ATTACHMENT D AMENDED SWMP

STORMWATER QUALITY MANAGEMENT PLAN

AURA PRECINCT 15 WEST

The report (Revision E) has been prepared to address changes to the stormwater quality management strategy, which includes removal of GPTs and At-Source WSUD devices for water quality treatment of runoff from the catchments of the future childcare centre, centres, community and multiple residential sites (Lot 8100 to 8103) within the Precinct. These changes are identified as indented italicised text or are noted as updated in table and figure captions.

FIGURE 3-1 **PRECINCT 15 WEST AT-SOURCE STORMWATER QUALITY MANAGEMENT (UPDATED)**

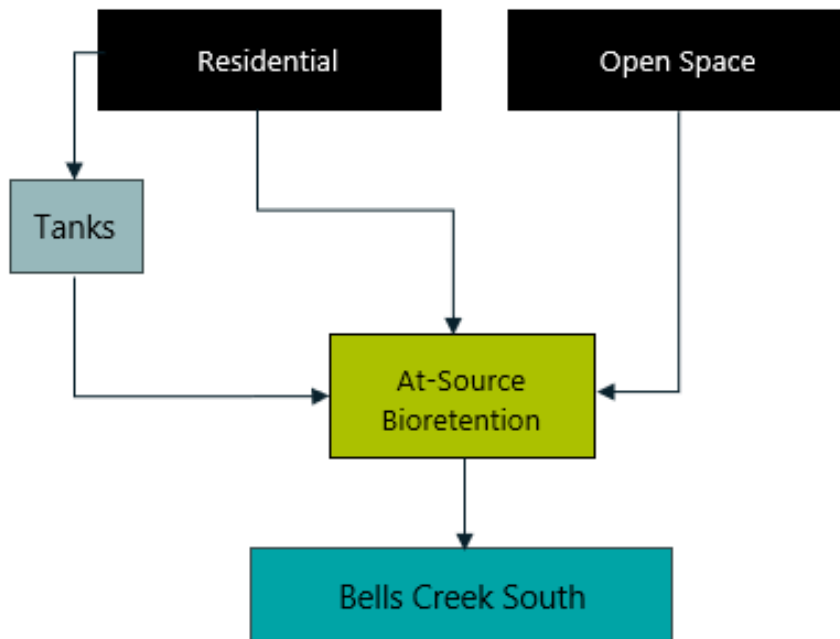
To illustrate the proposed treatment strategies **Figure 3-1** (updated) and **Figure 3-2** (updated) are provided below.

FIGURE 3-3 STORMWATER QUALITY IMPROVEMENT DEVICE LAYOUT (UPDATED)

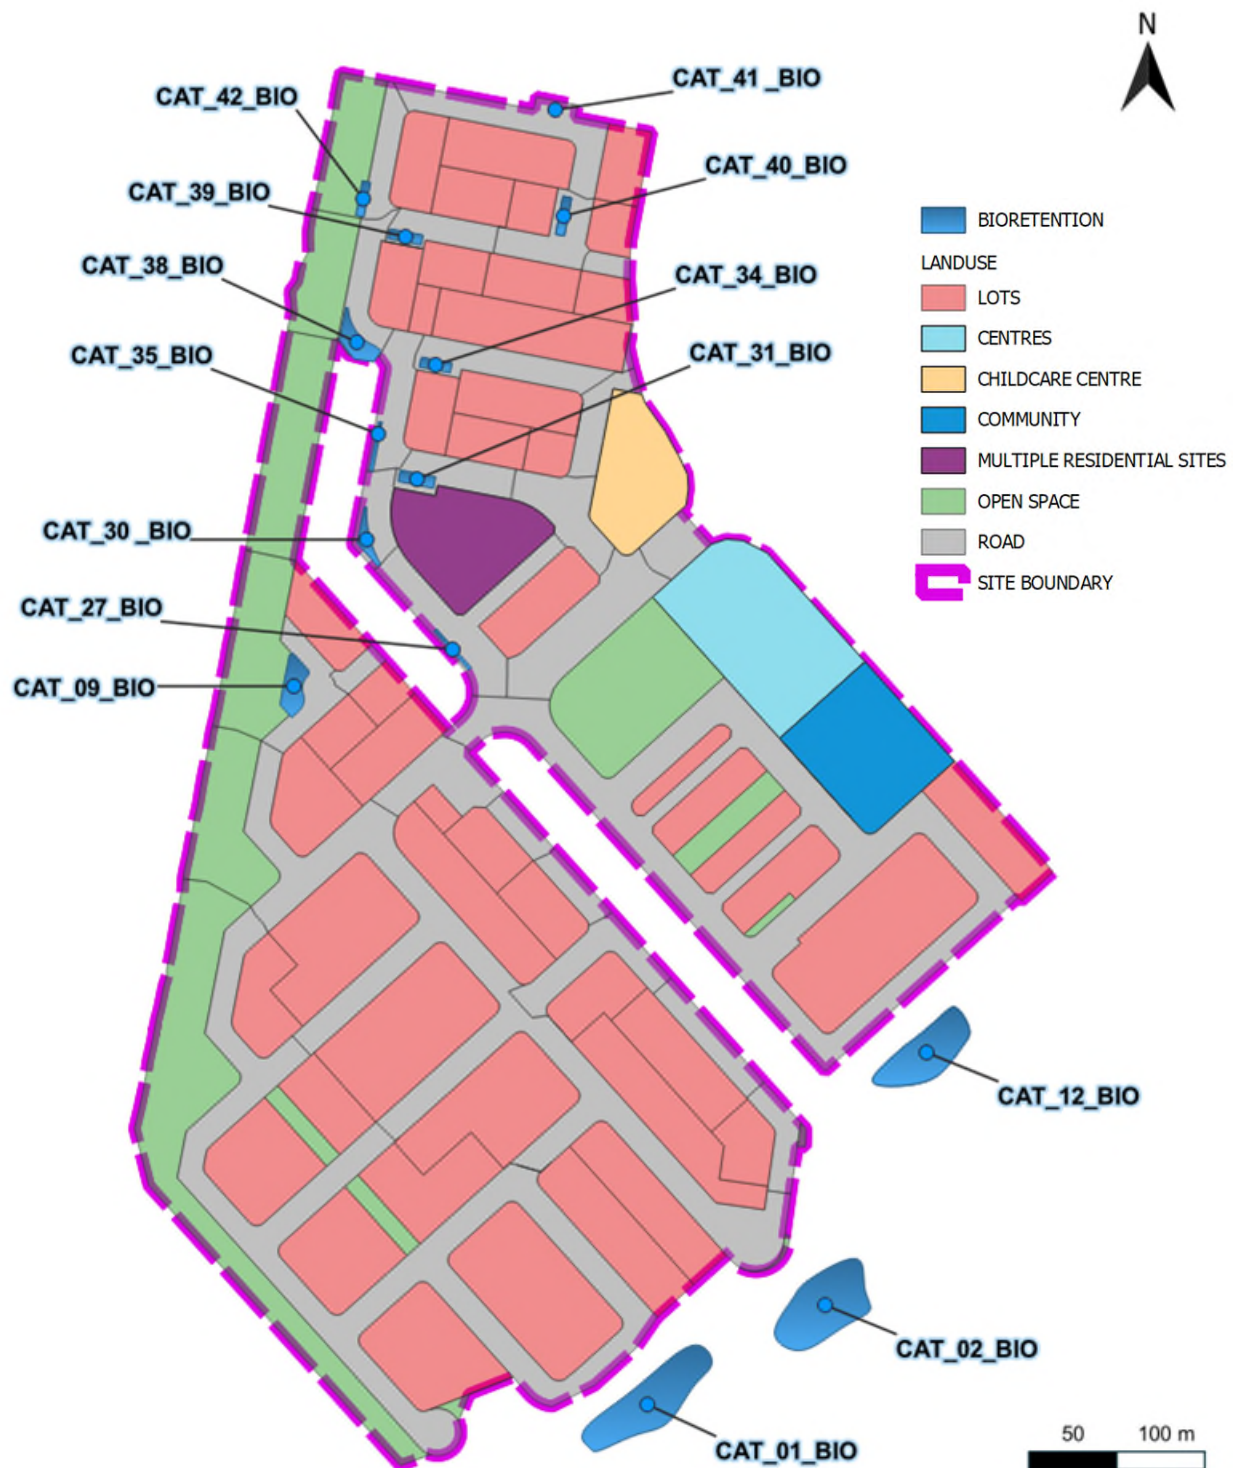
- The at-source bioretention CAT_10_BIO, from CAT_12_BIO to CAT_24_BIO and CAT_37_BIO have been removed. An end-of-line bioretention basin (CAT_12_BIO) is now proposed in their place to meet the Water Quality Objectives. Refer to Figure 3-3 for further details. This addressed Items 1f and 1g of RFI2.

- To address Item 3a of the EDQ Further Issues Letter the Gross Pollutant Trap (GPT;'s) 1, 2 and 12 have been removed from the strategy. Refer to **Figure 3-3** for the updated layout of the proposed stormwater quality improvement devices.

Figure 3-3 below provides an overview of the proposed stormwater quality improvement devices and land use characteristics.
